**Subject: PH2876**

**Design Change:**

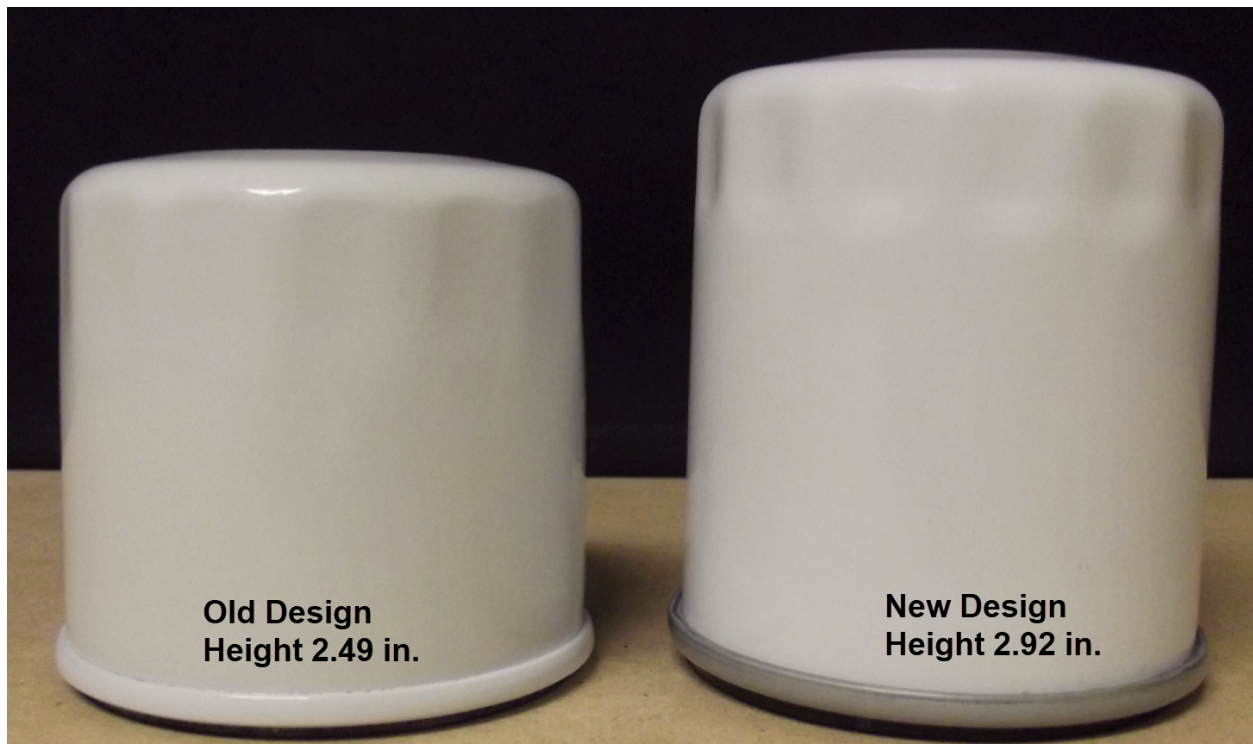
A manufacturing change has been implemented on the PH2876.

Slight differences can be seen in height and outside diameter as noted.

There is no change in fit or function, and the new design meets all engine application requirements.

The installer will not experience any interference issues with this new design.

Outside diameter of old design is 2.66 in.

Outside diameter of new design is 2.70 in. This increase does not affect the sealing surface area of the filter.
